<b>Docket Number:</b>	21-AFC-02
<b>Project Title:</b>	Willow Rock Energy Storage Center
<b>TN #:</b>	259220
<b>Document Title:</b>	Willow Rock Data Request Set 2 Response
<b>Description:</b>	N/A
<b>Filer:</b>	Kathryn Stevens
<b>Organization:</b>	WSP USA Inc.
<b>Submitter Role:</b>	Applicant Consultant
<b>Submission Date:</b>	9/19/2024 11:11:49 AM
<b>Docketed Date:</b>	9/19/2024

**Willow Rock Energy Storage Center (21-AFC-02)**  
*Data Request Response Set 2*

## **Fuel Models Maps**

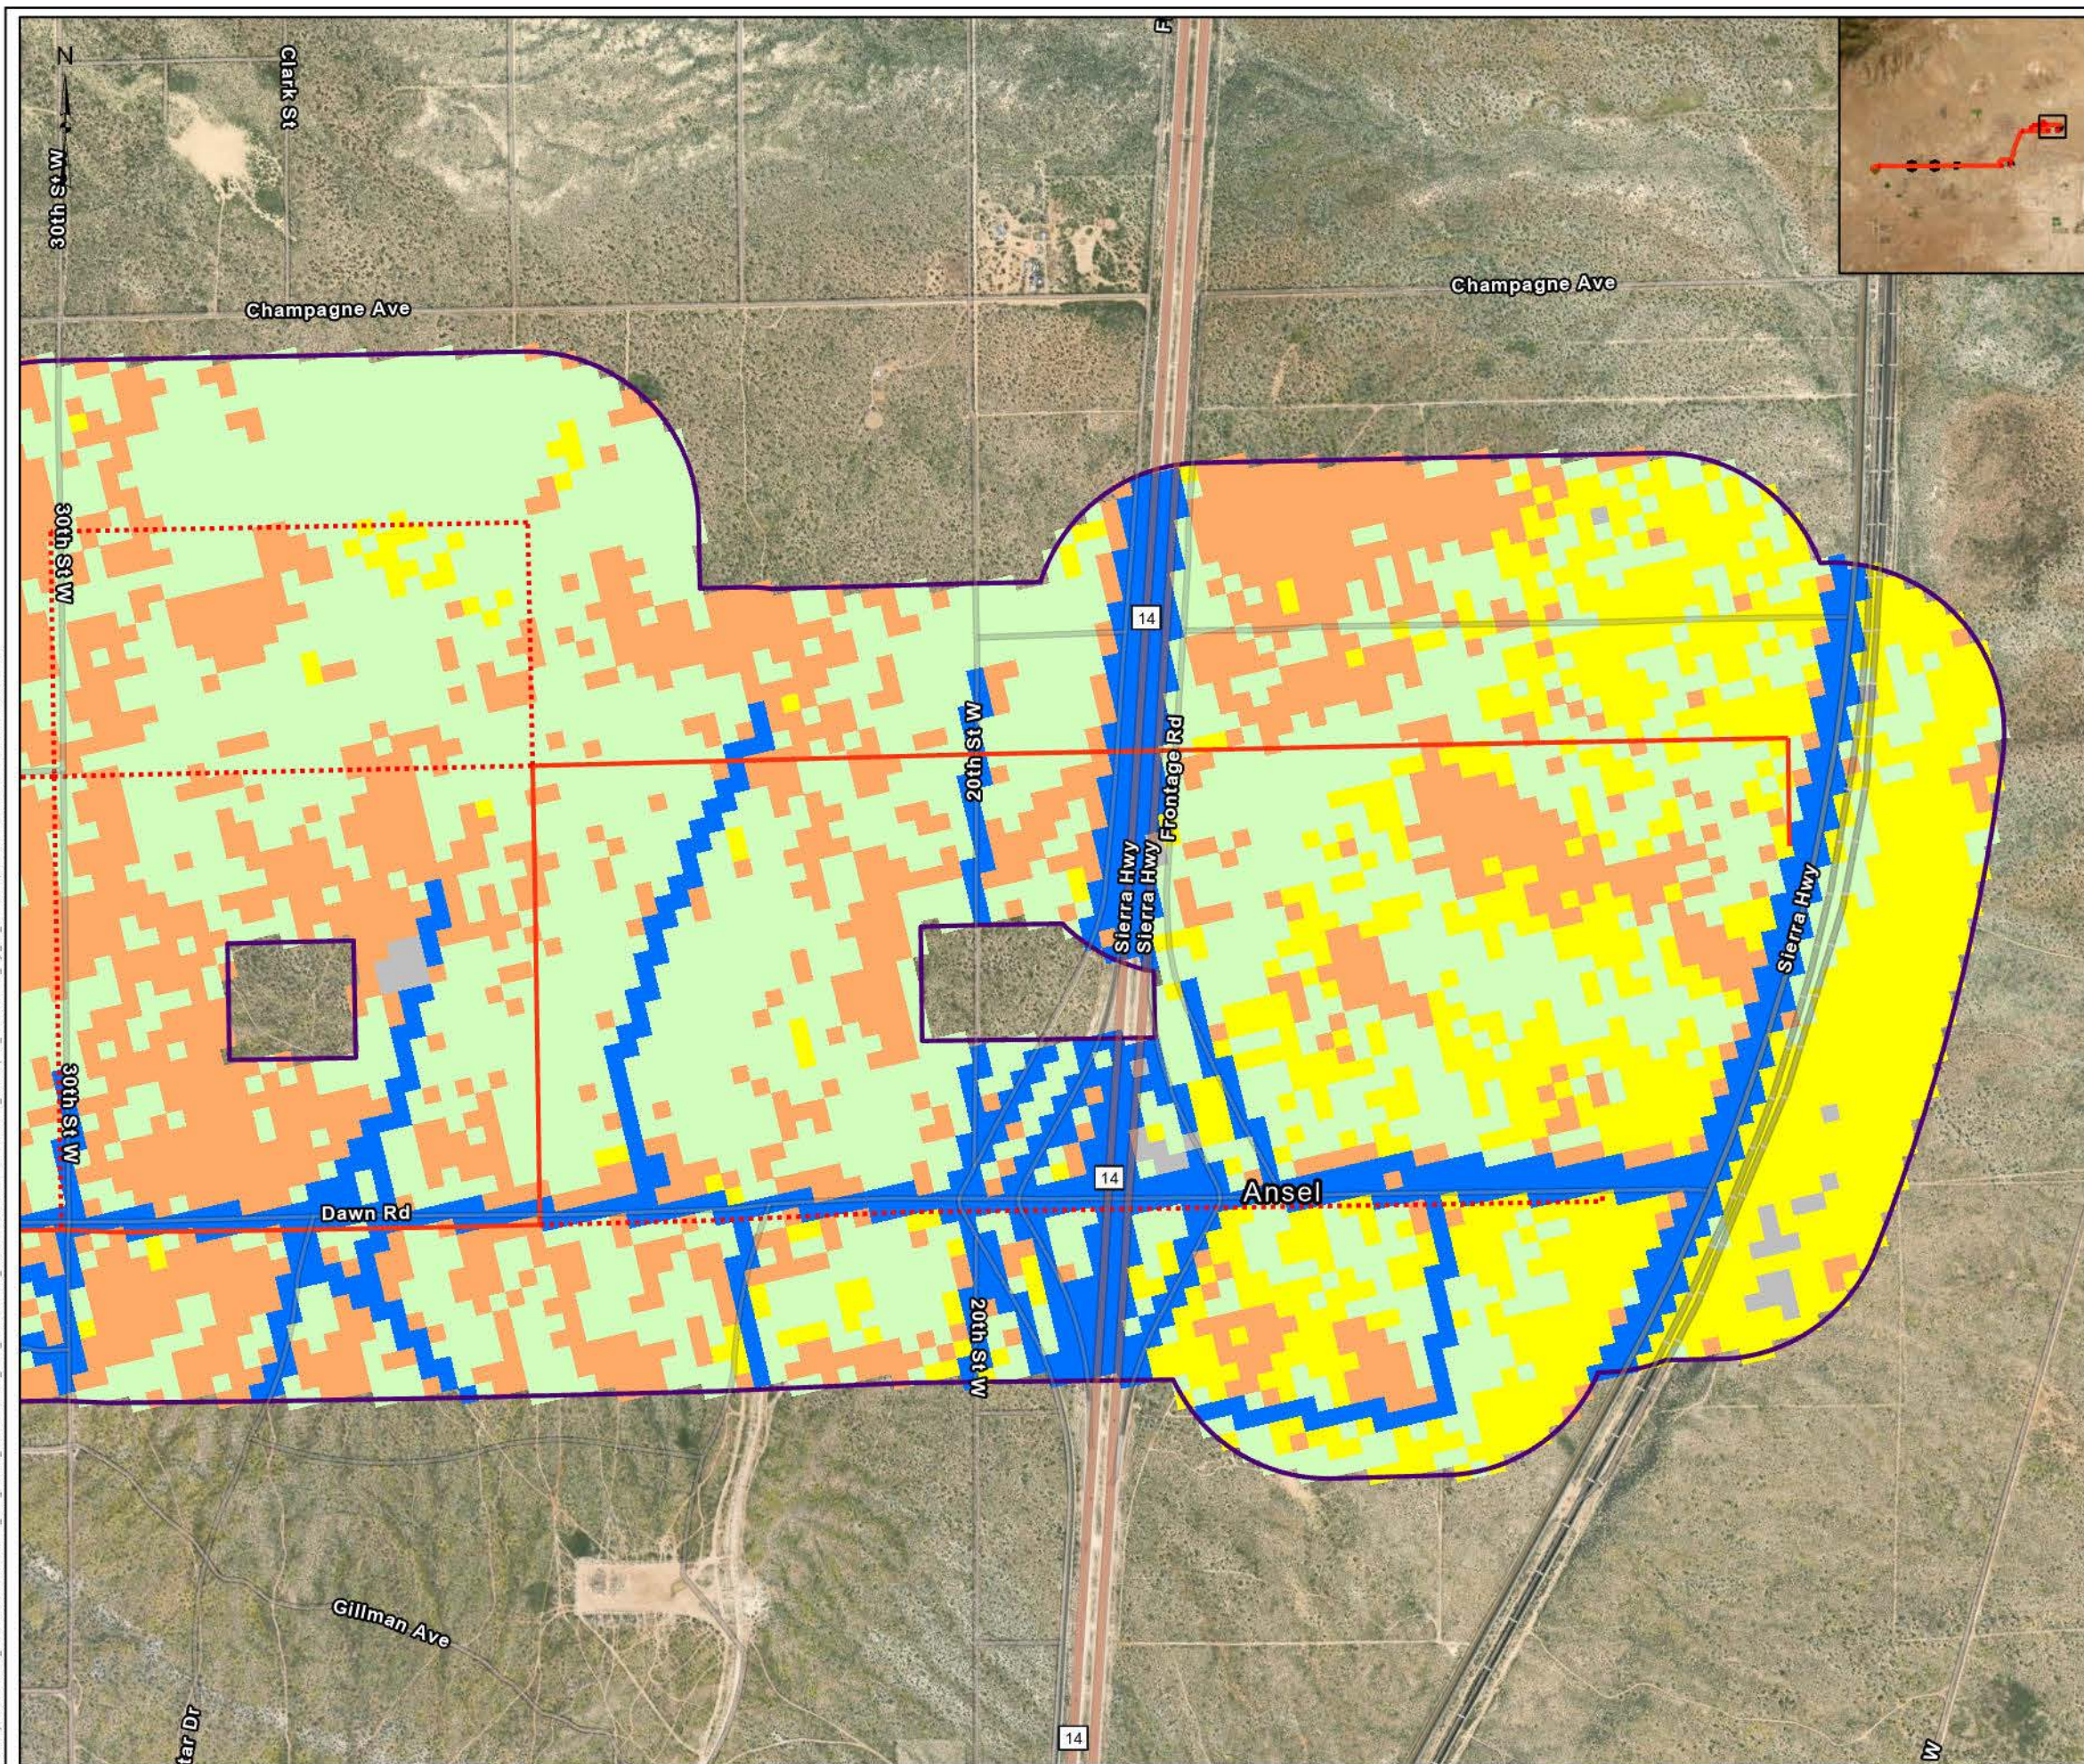
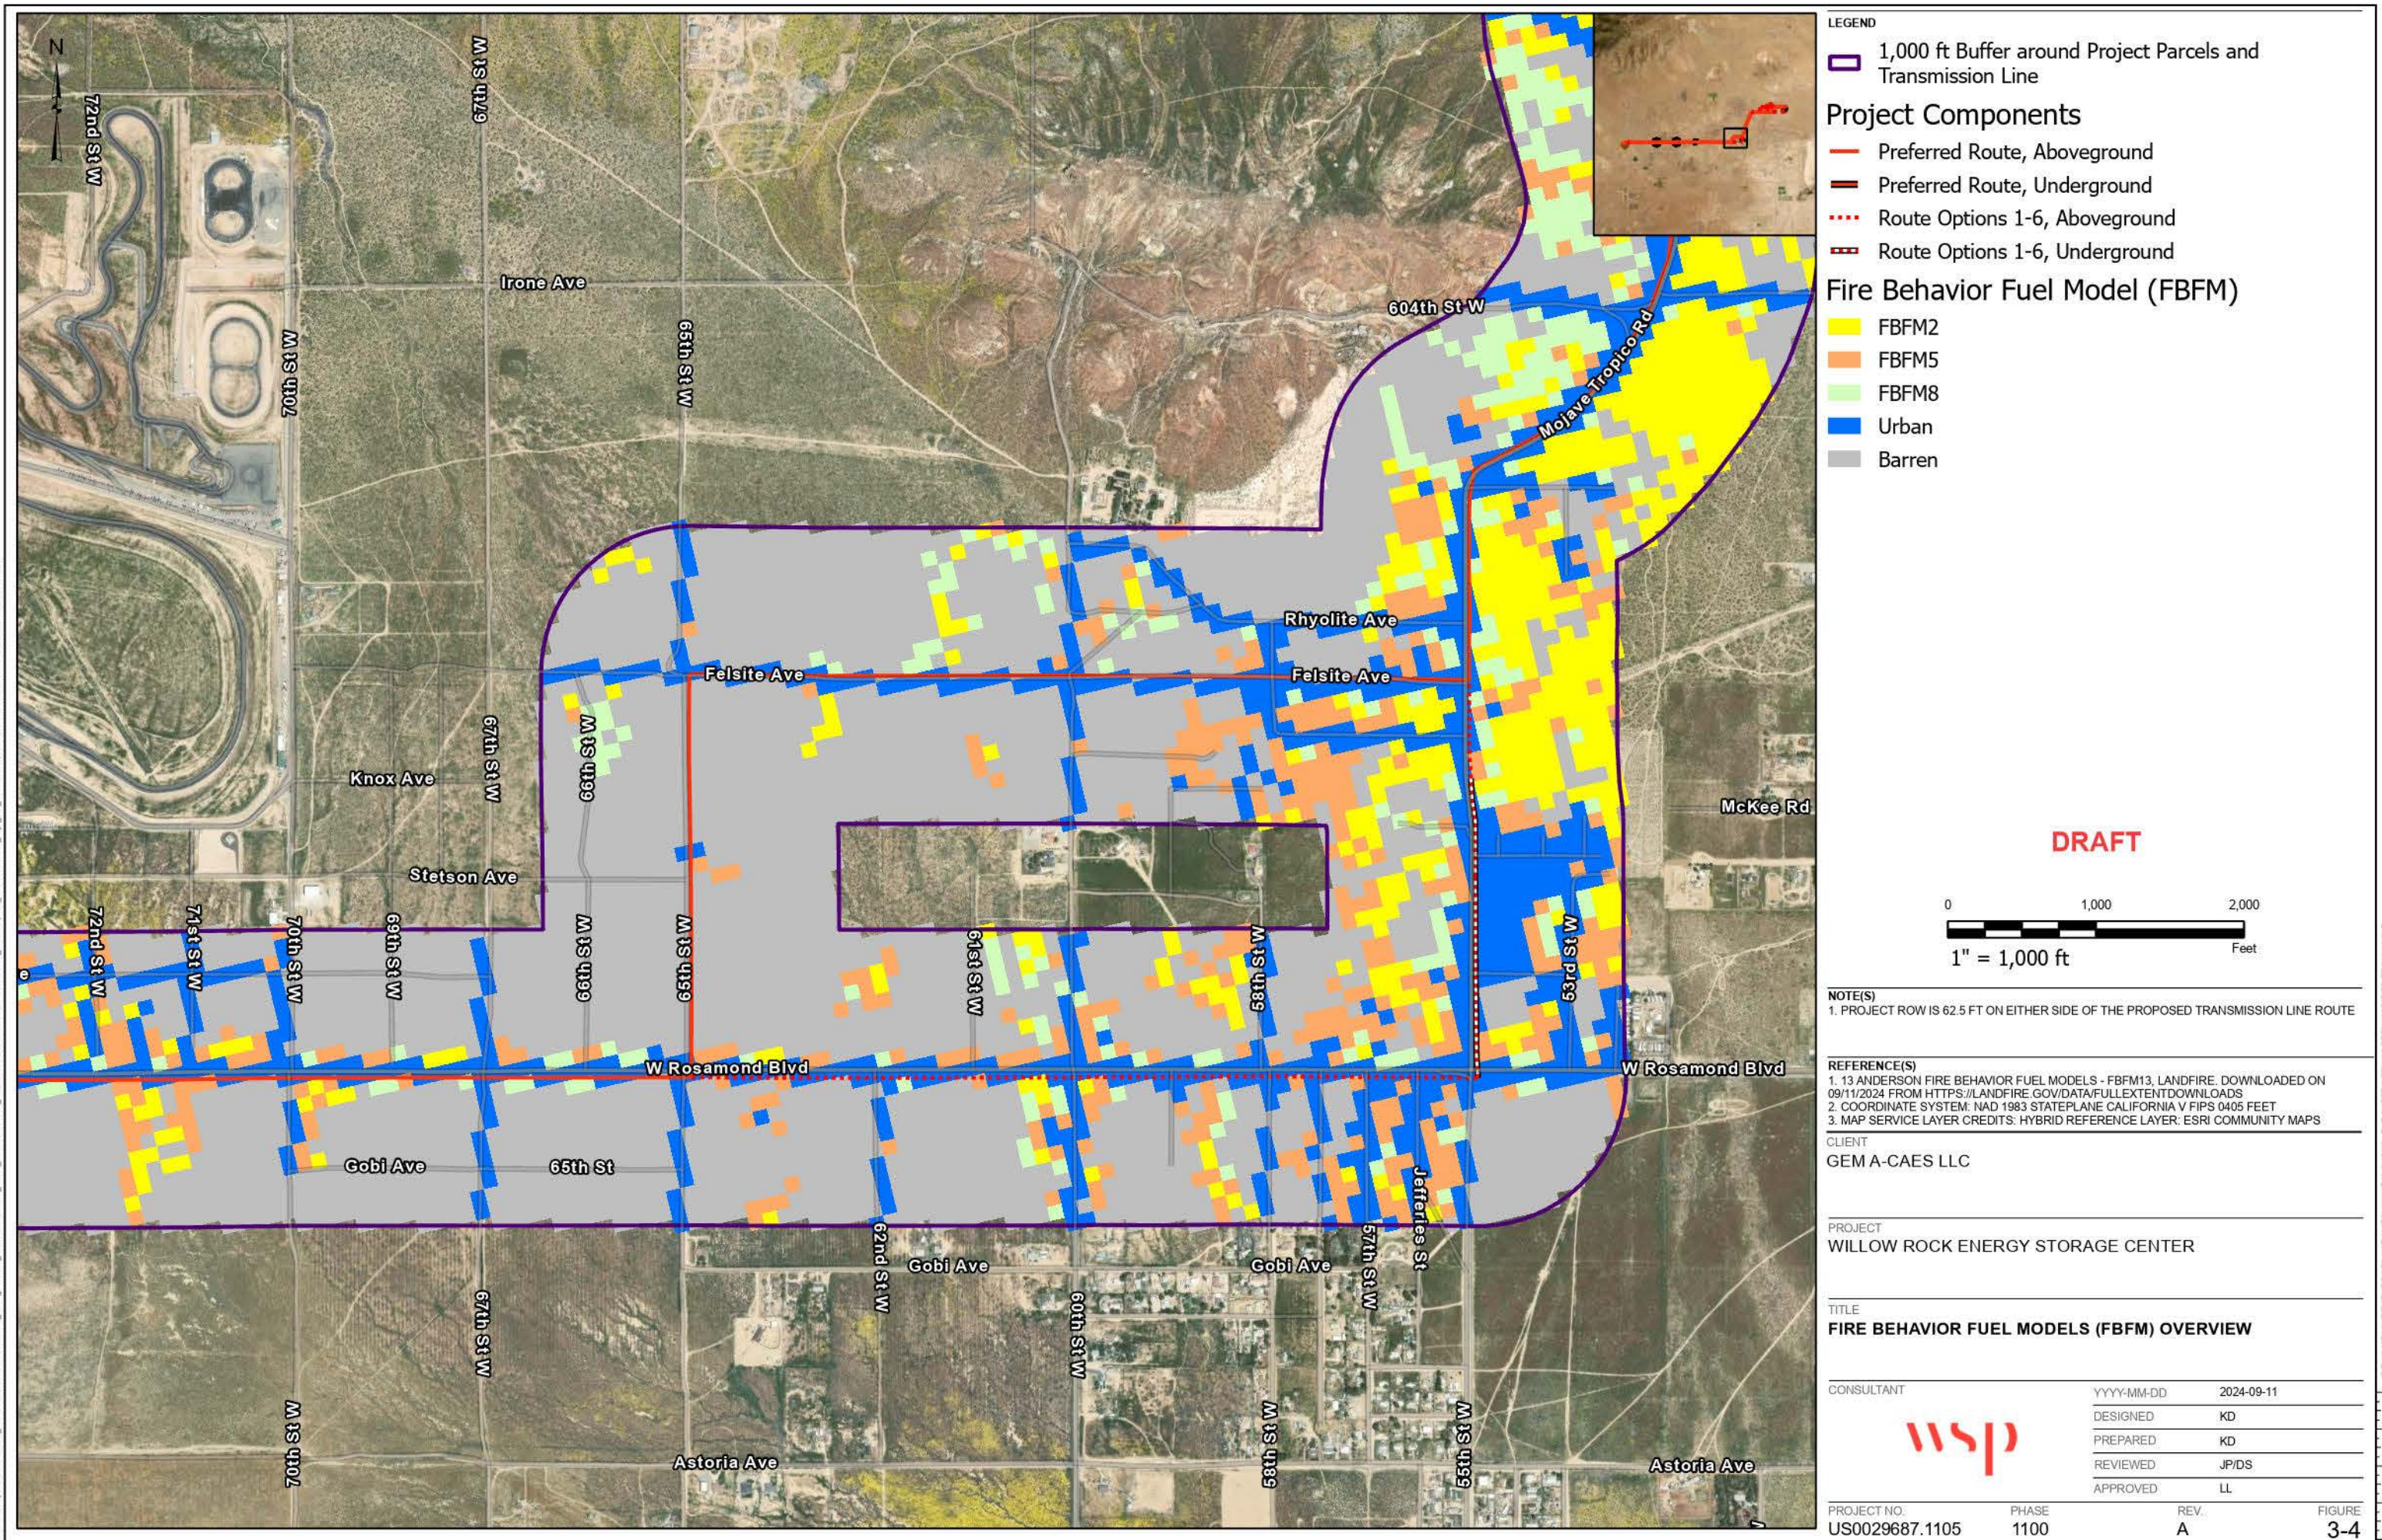
**DR36:** *Provide a discussion and map that indicates how each identified Fuel Model relates to the Project specifically and where they are in relation to each component of the Project, including the transmission line.*

**Response:** Attachment DR36-1 provides a map showing the relevant fuel models in relationship to project components. The following describes how each fuel model geographically relates to the Project:

- Based on data from LANDFIRE, the fire behavior fuel models (FBFM) surrounding the transmission line and Project components are FBFM2, FBFM5, and FBFM8.
- FBFM2 dominates the area on the eastern side of the WRESC site
- FBFM5 and FBFM8 make up the areas to the west of the WRESC site along Dawn Road.
- FBFM2 dominates the area surrounding Mojave Tropic Road.
- The majority of Rosamond Boulevard is surrounded by urban areas that do not include an FBFM, however FBFM2, FBFM5, and FBFM8 are dispersed along some sections of the road, with FBFM5 being the most dominant.
- The Whirlwind Substation is mostly surrounded by FBFM2, however, both FBFM5 and FBFM8 occur on the northeast side of the substation.
